PLANNING REPORT

Minto Renewal Area Assessment of Part 3A Application

**Campbelltown City Council, Landcom and
Department of Housing**

Figure 2: Master Plan

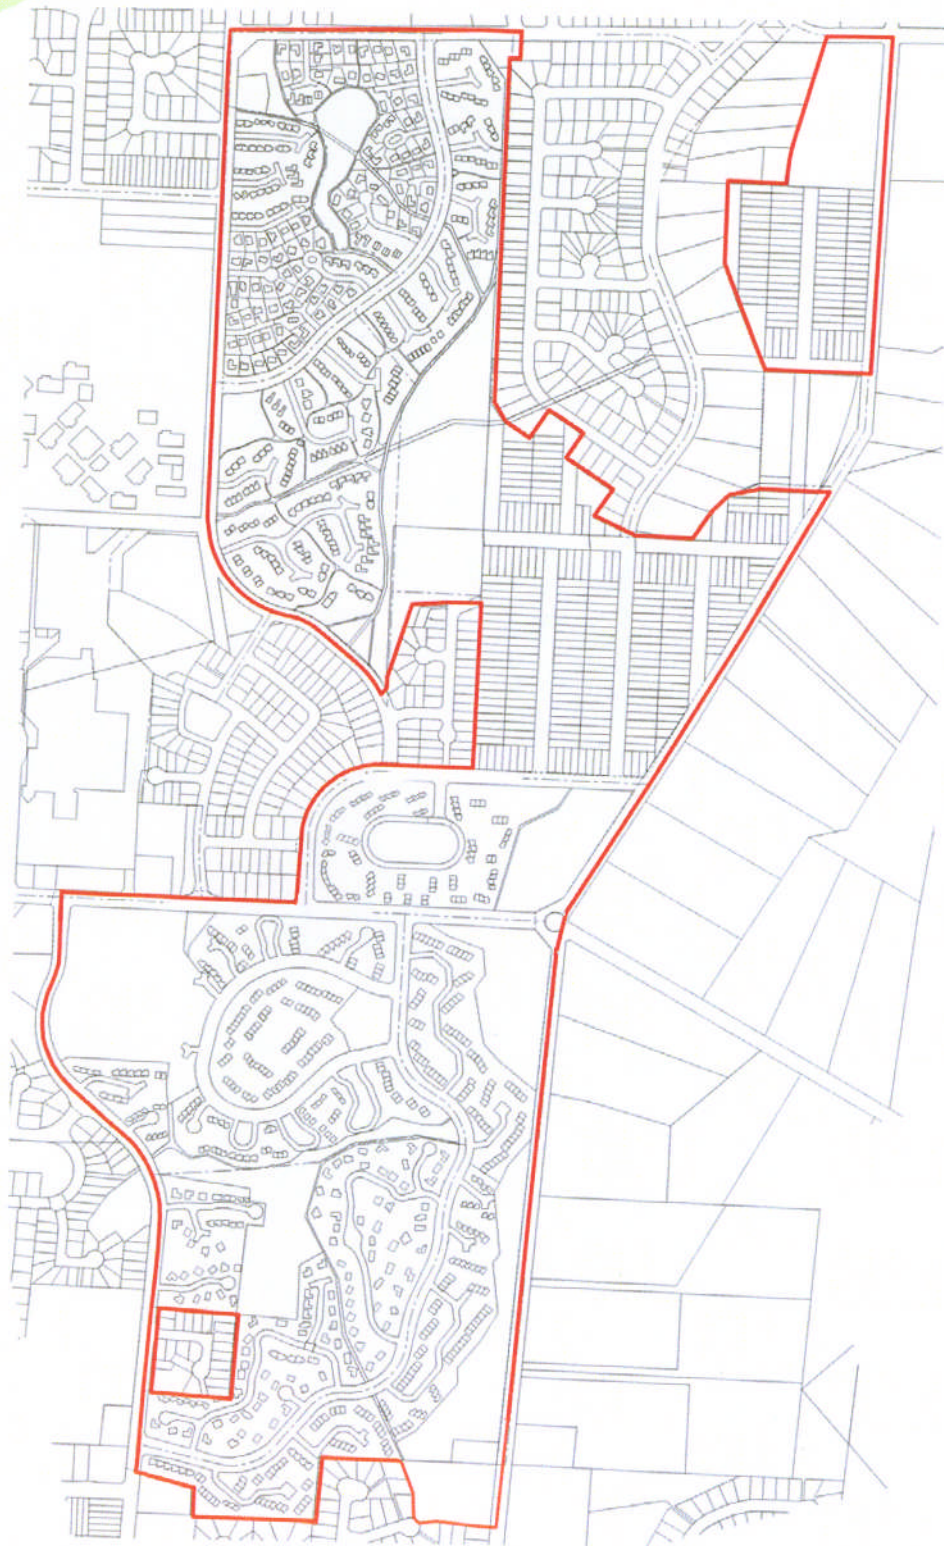
- 1) The urban design characteristics of the Master Plan (i.e. road, pedestrian and cyclist networks, distribution of open spaces and land use densities) generally exhibit the adoption of appropriate urban design techniques that consider landform and setting and the urban renewal objectives in Part I of the Environmental Assessment Report.

- 2) The connected street network and superlots created from the street layout provide for the subdivision of land into detached or integrated dwelling sites. However, the proposed lot layout presented in some of the Figures at the rear of the Environmental Assessment Report (though described as 'Preliminary' in header to these pages, raising questions as to their status) includes some odd and inefficient shaped allotments that would ordinarily represent poor design. In light of the retrospective nature required of the urban design task (i.e. to retrofit a new subdivision into an established area), the configuration of lots is acceptable in the circumstances.
